App. No. 10/724,436  
Amendment dated 02/17/2005  
Reply to Office Action of 11/17/2004

**AMENDMENTS TO THE DRAWINGS**

In re: Martin et al. Serial No. 10/724,436  
For: BRAZED SHEETS WITH ALIGNED  
OPENINGS AND HEAT EXCHANGER FORMED  
THEREFROM

ANNOTATED SHEET

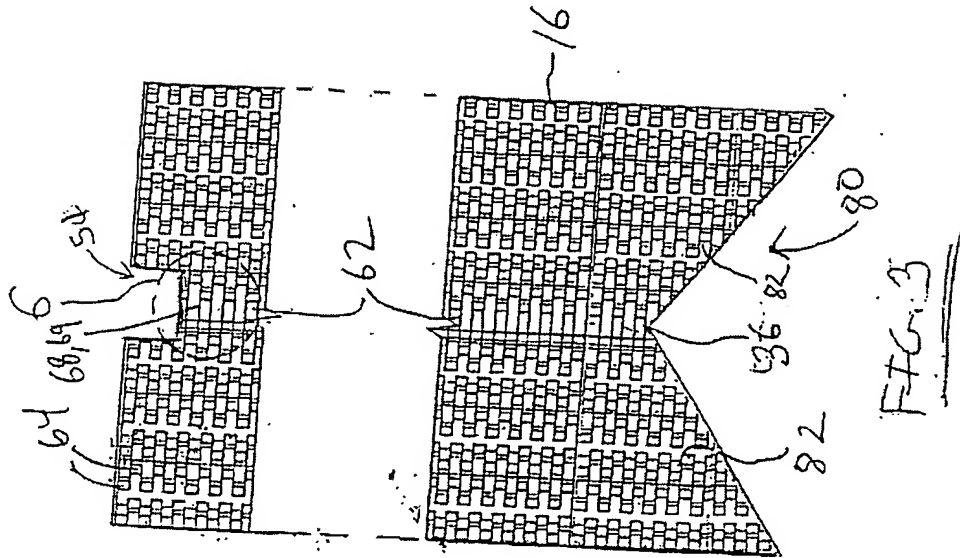
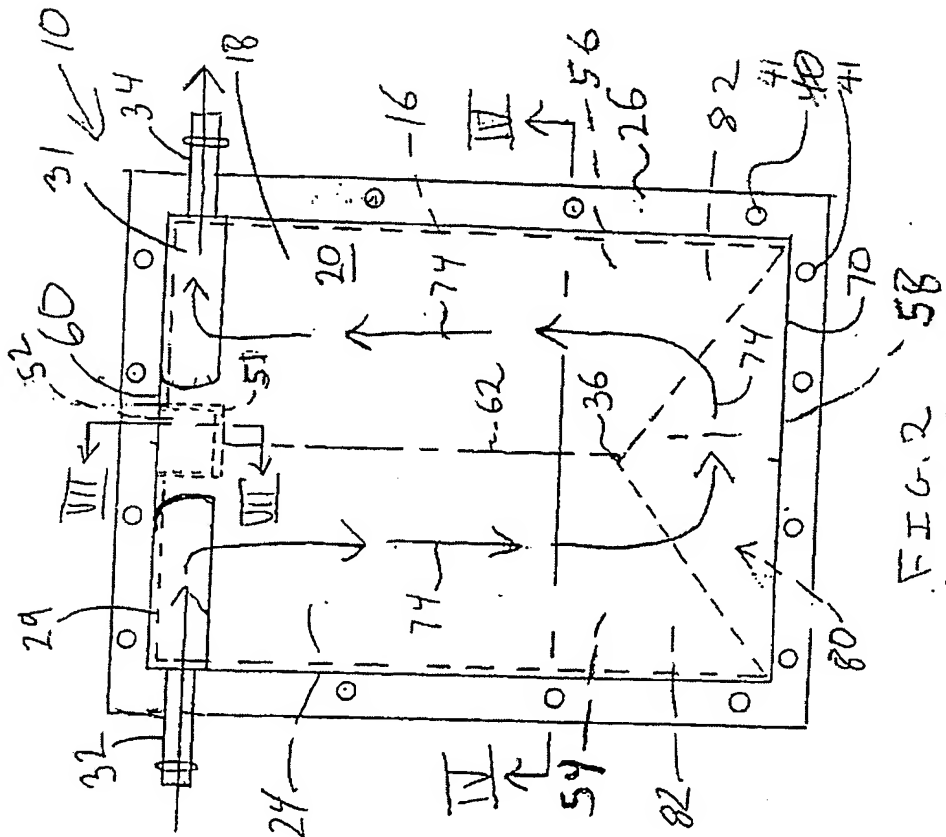
In addition, some minor corrections have been made to Figures 1, 2, 5, 13 and Figures 14A to 14D and sheets of the original drawings containing these figures are enclosed in the Appendix. These sheets are marked as "ANNOTATED" to indicate the amendment made in the formal drawings.

In particular, the reference number 40 used to identify the fastener holes in the cover plate has been replaced by number -- 41 -- while the reference numbers "42" used to indicate the fastener holes in the plate 14 have been changed to -- 43 --. These changes were necessary in order to avoid the use of the same reference number to identify different features.
